SUBJECT: ISSUANCE OF AMENDMENT FOR SAN ONOFRE NUCLEAR GENERATING STATION,
UNIT NO. 2 (TAC NO. M94624) AND UNIT NO. 3 (TAC NO. M94625)

AMENDMENT TO FACILITY OPERATING LICENSE

ATTACHMENT TO LICENSE AMENDMENT

SAFETY EVALUATION BY THE OFFICE OF NUCLEAR REACTOR REGULATION
RELATED TO AMENDMENT NO. 131 TO FACILITY OPERATING LICENSE NO. NPF-10
AND AMENDMENT NO. 120 TO FACILITY OPERATING LICENSE NO. NPF-15
SOUTHERN CALIFORNIA EDISON COMPANY
SAN DIEGO GAS AND ELECTRIC COMPANY
THE CITY OF RIVERSIDE, CALIFORNIA
THE CITY OF ANAHEIM, CALIFORNIA
SAN ONOFRE NUCLEAR GENERATING STATION, UNITS 2 AND 3
DOCKET NOS. 50-361 AND 50-362

FIGURE 3.7.18-1

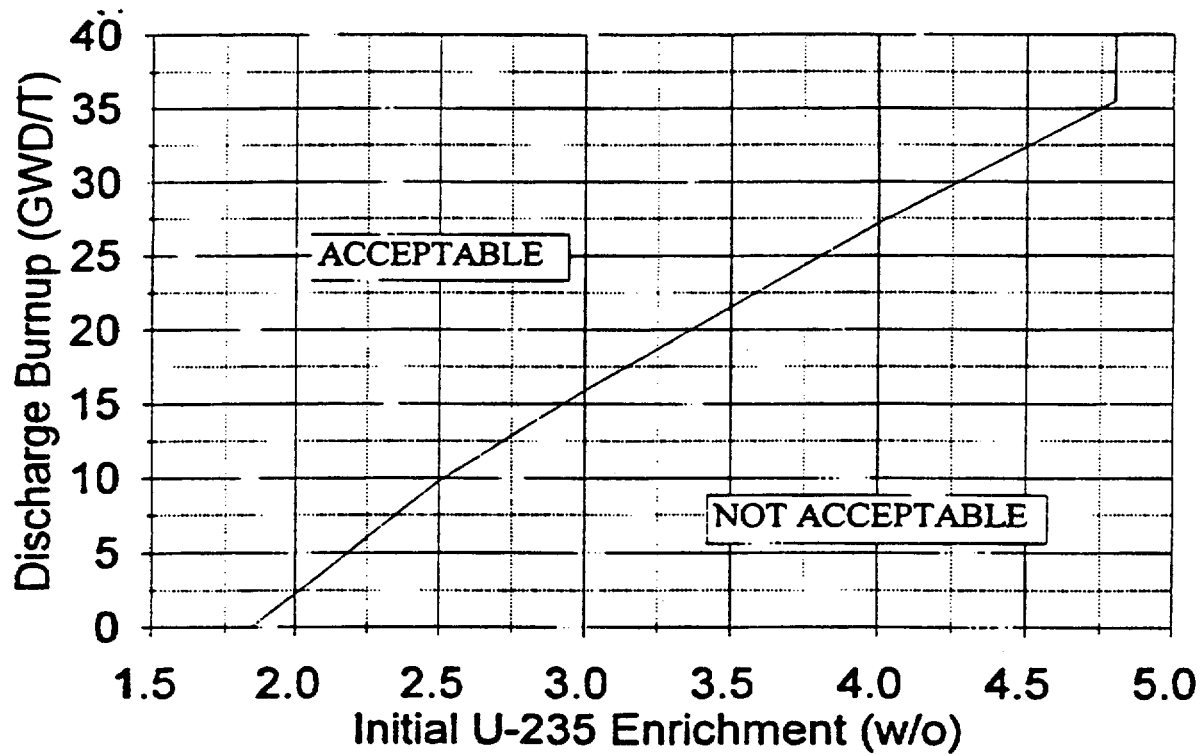
LCO 3.7.18 The combination of initial enrichment and burnup of each SONGS 2 and 3 spent fuel assembly stored in Region II shall be within the acceptable burnup domain of Figure 3.7.18-1 or Figure 3.7.18-2, or the fuel assembly shall be stored in accordance with Licensee Controlled Specification 4.0.100.

- e. Units 1, 2, and 3 fuel assemblies may be stored in Region I with no restrictions;
- f. Units 2 and 3 fuel assemblies with a burnup in the "acceptable range" of Figure 3.7.18-1 are allowed unrestricted storage in Region II;

assemblies in Region II rack locations. Another single value is being provided as a burnup limit for storage of Unit 1 spent fuel in the Region II peripheral rack locations. Therefore, the current Figure 3.7.18-1 is being replaced with a curve applicable to Units 2 and 3 fuel assemblies and relabeled appropriately.

FIGURE 3.7.18-2

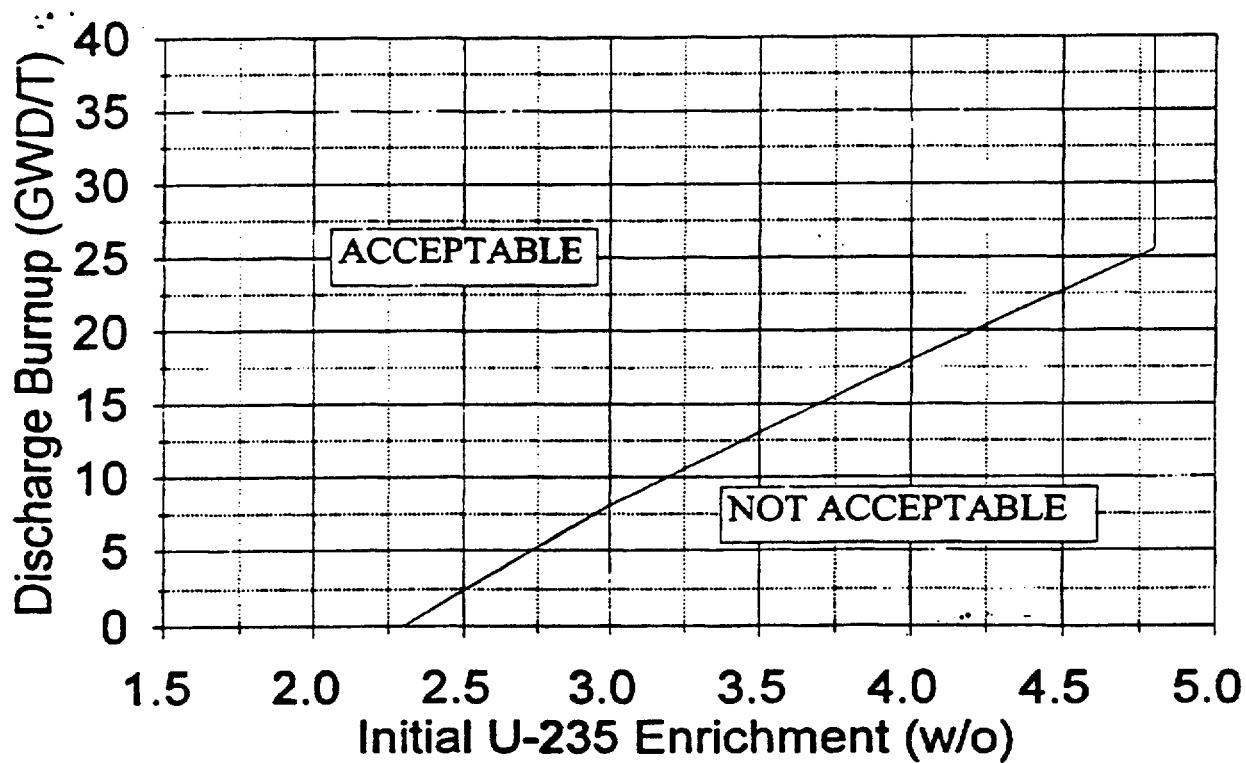
- g. Units 2 and 3 fuel assemblies with a burnup in the "acceptable range" of Figure 3.7.18-2 are allowed unrestricted storage in the peripheral pool locations with 1 or 2 faces toward the spent fuel pool walls of Region II;

Because of the high neutron leakage from the peripheral cells which face the pool walls in Region 2, additional calculations were performed to determine the burnup required for safe storage in these cells. Fresh 2.30 w/o U-235 enriched fuel or 5.10 w/o U-235 enriched fuel irradiated to at least 28.3 GWD/T can be stored in these peripheral locations and meet the 0.95 k_{eff} criterion.

FIGURE 3.7.18-1

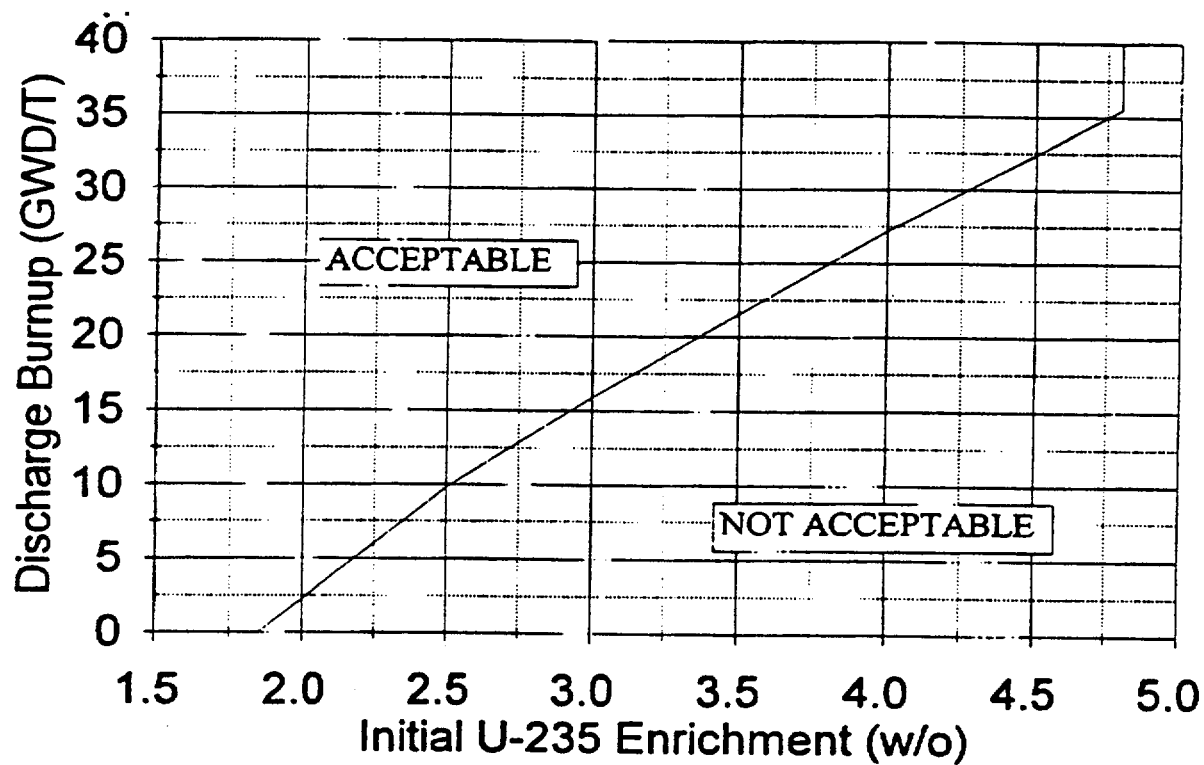
LCO 3.7.18 The combination of initial enrichment and burnup of each SONGS 2 and 3 spent fuel assembly stored in Region II shall be within the acceptable burnup domain of Figure 3.7.18-1 or Figure 3.7.18-2, or the fuel assembly shall be stored in accordance with Licensee Controlled Specification 4.0.100.

- e. Units 1, 2, and 3 fuel assemblies may be stored in Region I with no restrictions;
- f. Units 2 and 3 fuel assemblies with a burnup in the "acceptable range" of Figure 3.7.18-1 are allowed unrestricted storage in Region II;

FIGURE 3.7.18-2

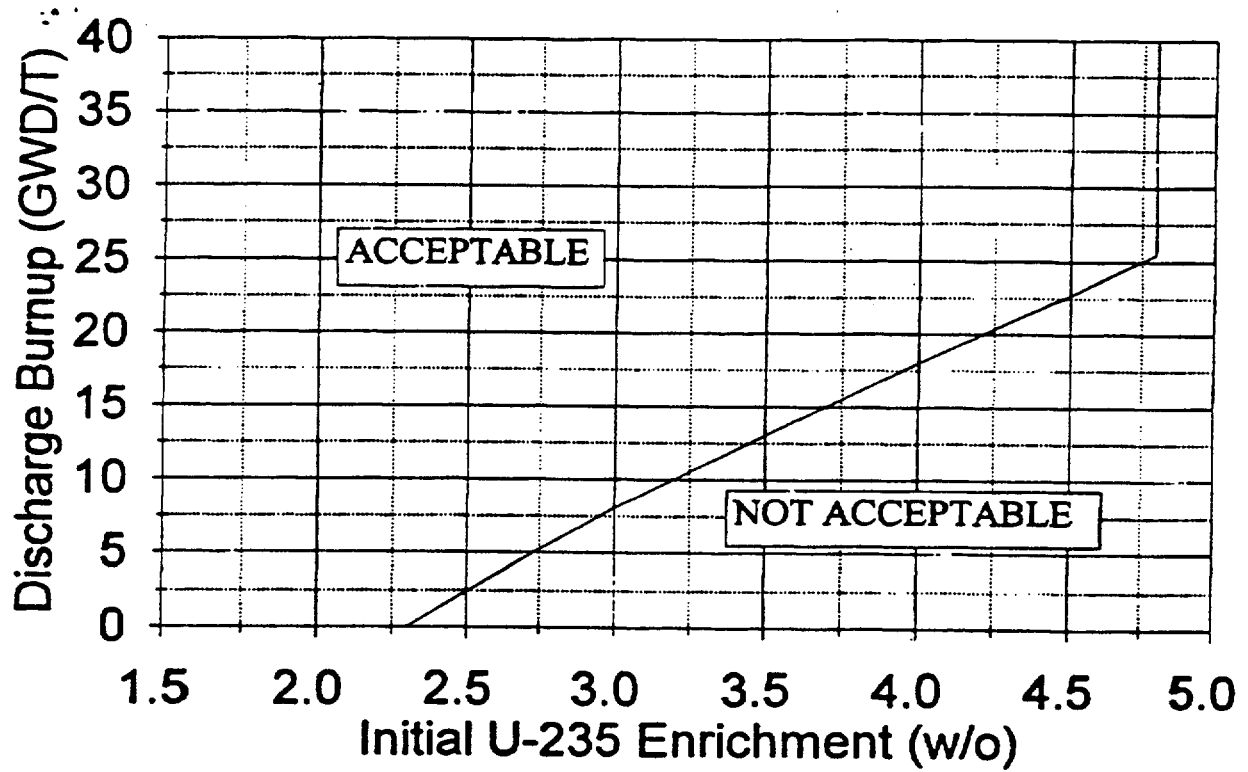
- g. Units 2 and 3 fuel assemblies with a burnup in the "acceptable range" of Figure 3.7.18-2 are allowed unrestricted storage in the peripheral pool locations with 1 or 2 faces toward the spent fuel pool walls of Region II;
